PCN – Process Change Notification

Change:	MA705 Series
Date:	2017/07/20
Author	Bonnie Chen

Model#	Part Number	Changes
MA705.A.ABC.001 MA705.A.ABC.002 MA705.A.ABC.003 MA705.A.ABC.004	-	1. Amend Details of Drawing

Illustration of Change

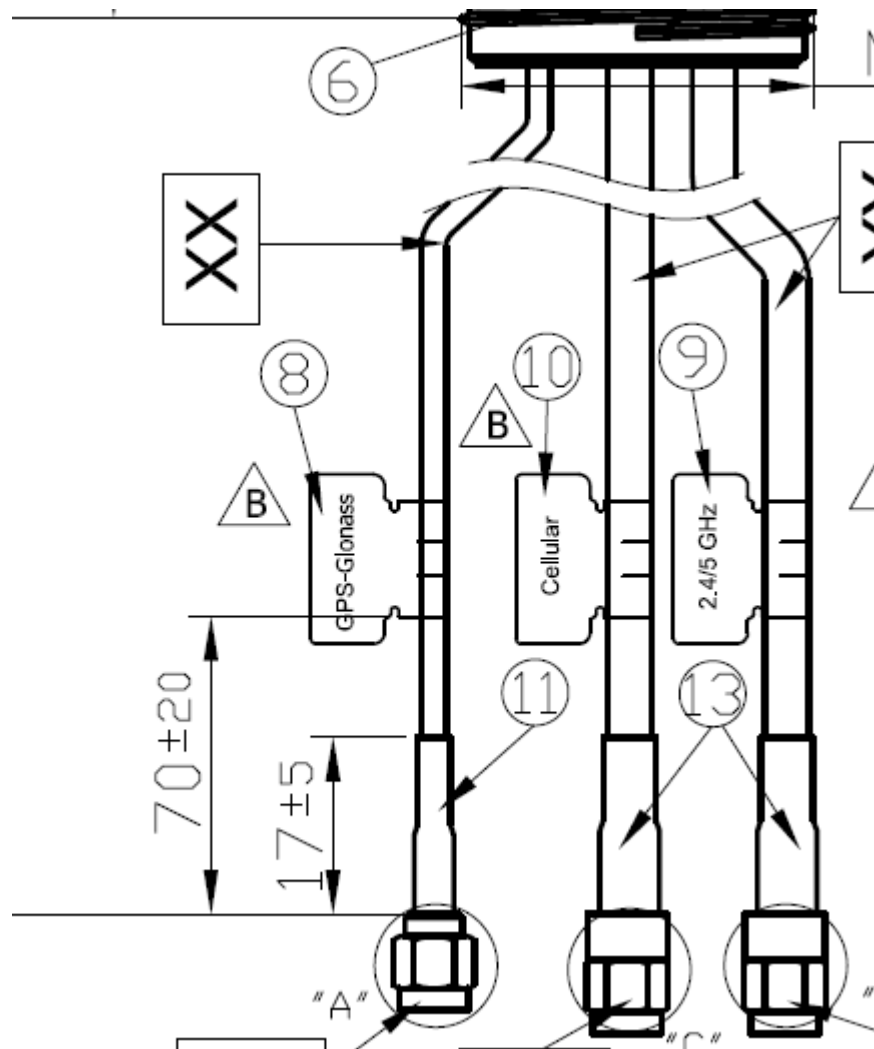
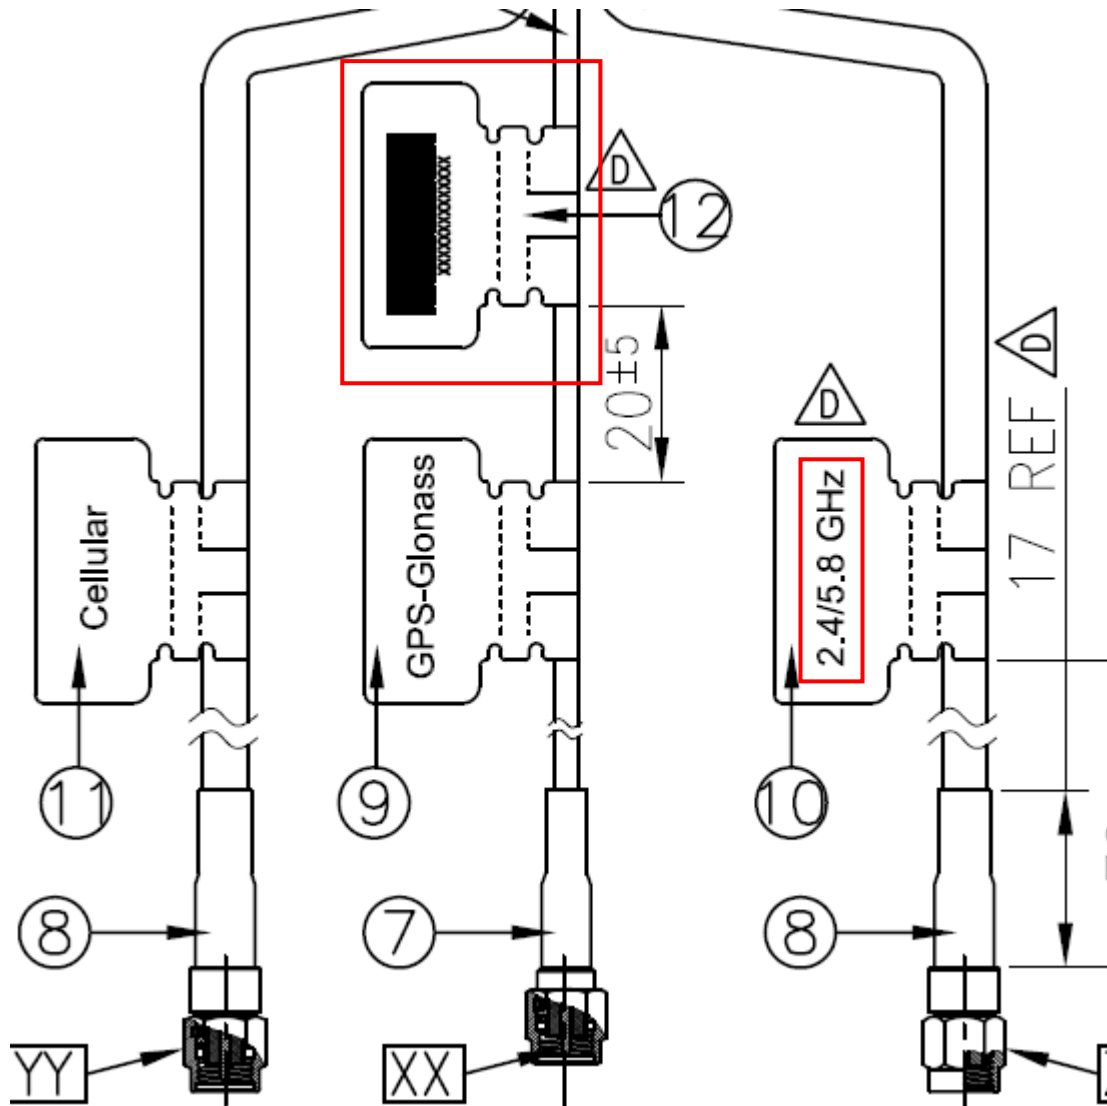
1. Add Barcode Label
2. Amend WiFi Label from “2.4/5 GHz” to “2.4/5.8 GHz”
3. Amend BOM..

8	GPS-Glonass Label	001012K010015A	Coated Paper	Orange	1
9	2.4/5 GHz Label	001013C010015A	Coated Paper	Green	1
10	Cellular Label	001013B010015A	Coated Paper	Blue	1

9	GPS-Glonass Label	001012K010015A	PEPA	Orange	1
10	2.4/5.8 GHz Label (48x30)	001016G070000A	PEPA	Teal Green	1
11	Cellular Label	001013B010015A	PEPA	Blue	1
12	Barcode Label	001013G000015A	PEPA	White	1
